Notice of Allowability

10/064,960

EXAMINER'S AMENDMENT

Fig. 2

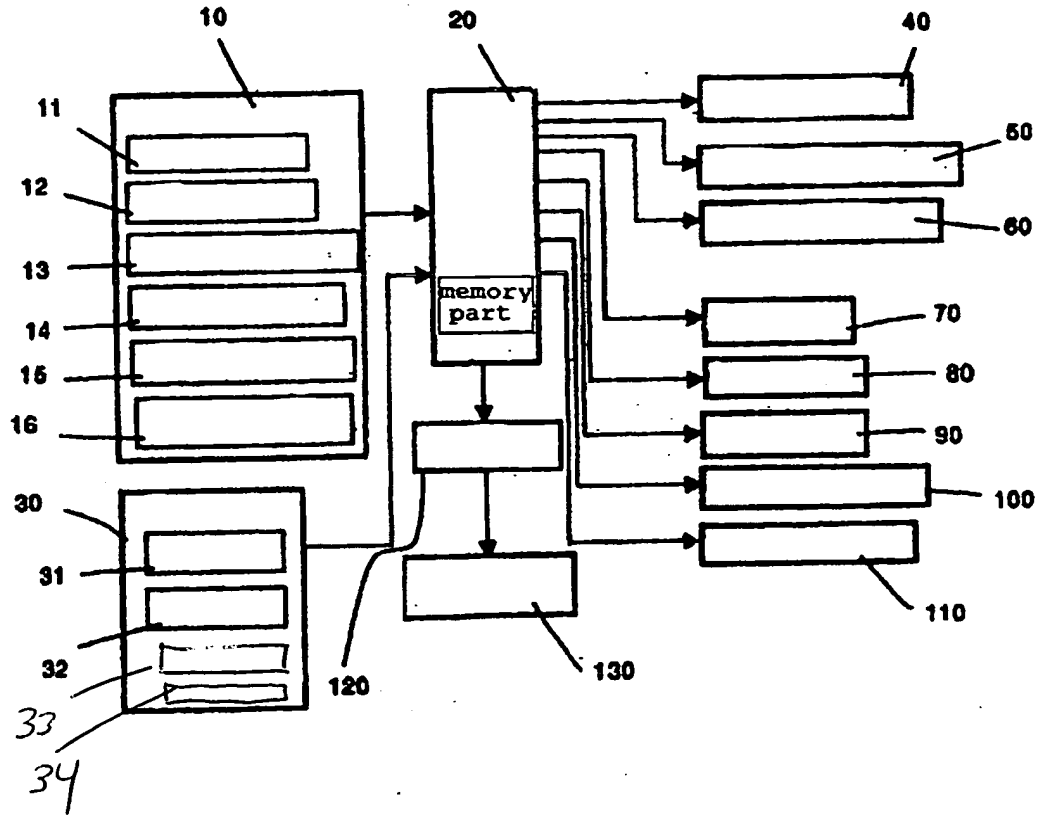
3. The drawings were received on August 16, 2005. These drawings are hereby disapproved because the line quality is poor and also because an amendment to the drawings is required as noted in greater detail below.

4. The following changes to the drawings have been approved by the examiner and agreed upon by applicant: each of a heater driving choice key and a odor emitting device driving choice key must be shown schematically in setting section 30 in Figure 2 and labeled using reference numbers 33 and 34, respectively, as shown in the attached marked-up copy of Figure 2. In order to avoid abandonment of the application, applicant must make these above agreed upon drawing changes.
